## **Opuha Dam**

### **Annual Safety Inspection 2015**

**Opuha Water Ltd**

Job No: 51137.028

Figure 2.2 Drain D18 flows, pre and post grouting (as per 2014 annual report)

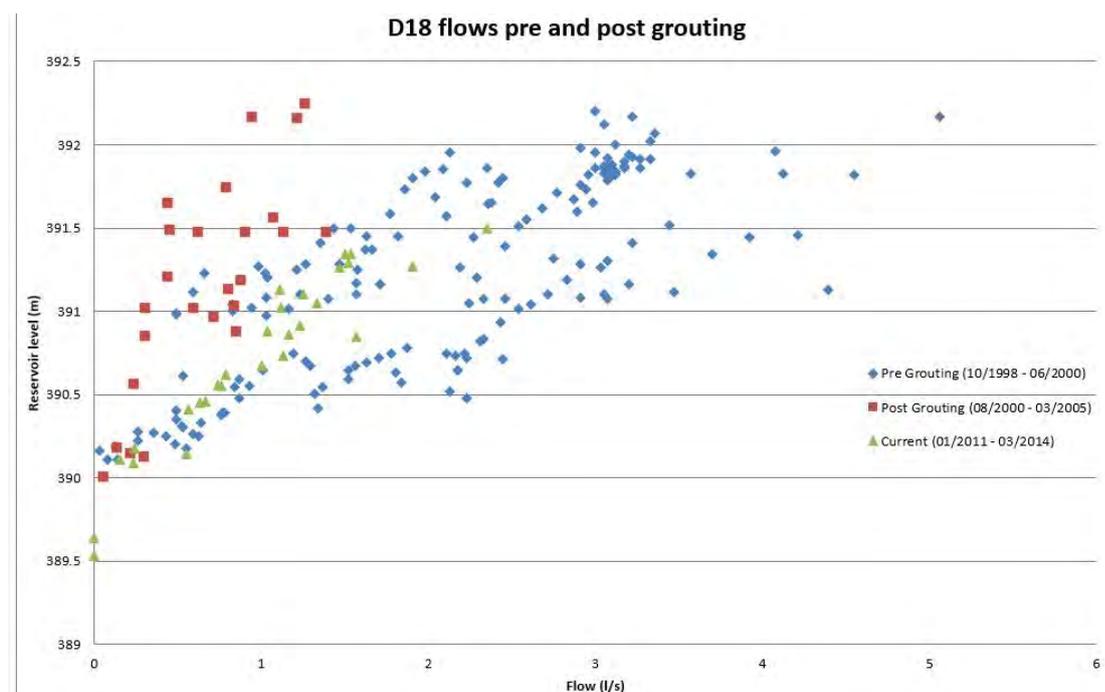
#### 2.2.5.1 D18 flow

Drain D18 is located at the RHS base of the auxiliary spillway fuse plug and only flows when reservoir levels exceed about 390 m RL. This level corresponds to the base of the right hand side auxiliary spillway channel.

Flows were observed and measured monthly between April – May 2014 & August - September 2014. The Alert Level was marginally exceeded on 27 May 2014 (by 0.11 l/s).

There is a long term trend of increasing flow from this drain since grouting was carried out on the upstream three metres of D18 in July 2000. The results of this can be seen in Figure 2.2 below which shows the flows produced pre-grouting, post-grouting and current flows from the drain.

It is important that close attention is given this area in order to better understand long term trend associated with seepage in the vicinity of D18.

Photo 5-4 Service spillway

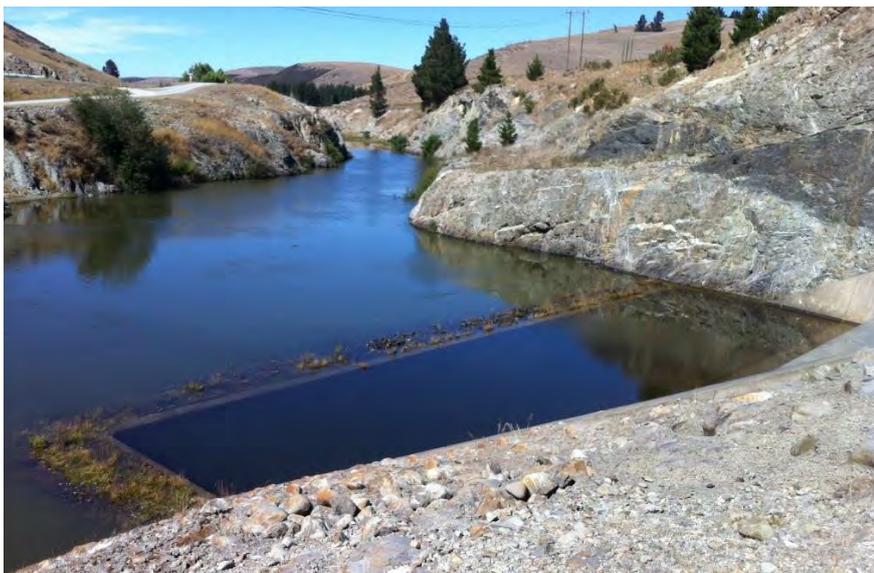
The spillway steps appeared to be in satisfactory condition. A few medium sized rocks were noted on the spillway, but there was no visible damage of major significance at this time to the step edges (refer Photo 5-4 below).

*Photo 6-3 Left abutment survey marker*

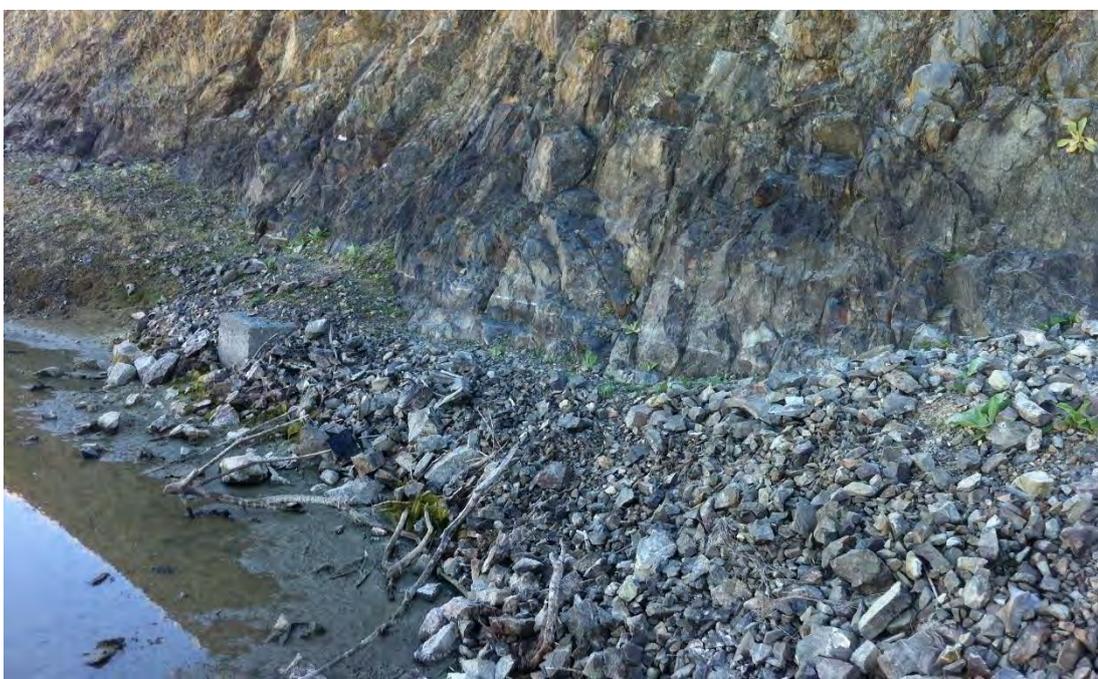
A survey benchmark was exposed at the toe of the true left abutment by the auxiliary spillway cut (refer Photo 6-3 below), due the very low reservoir level.

Figure 7-1 Excerpt from As-built Drawing 13897-5-S05 showing draft tube outlet and tailbay areas of observed damage (circled in red)

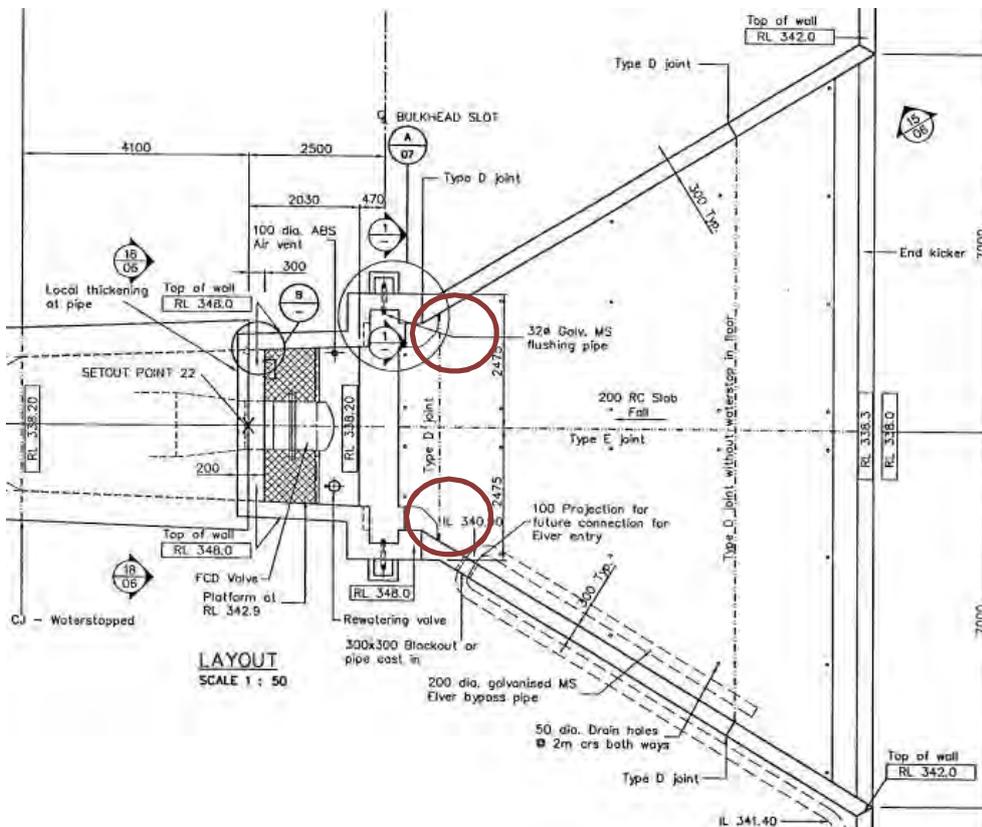
The recommendation from the dive inspection carried out in 2008 (RCM2008-32) has yet to be fully resolved, but is in progress. RCM2008-32 states that the observed damage to the draft tube outlet/tailbay concrete should be investigated in greater detail to assess the effects and consequences and determine whether immediate repairs are required.

RCM2015-06 Investigate options and undertake repair to damaged draft tube outlet concrete.
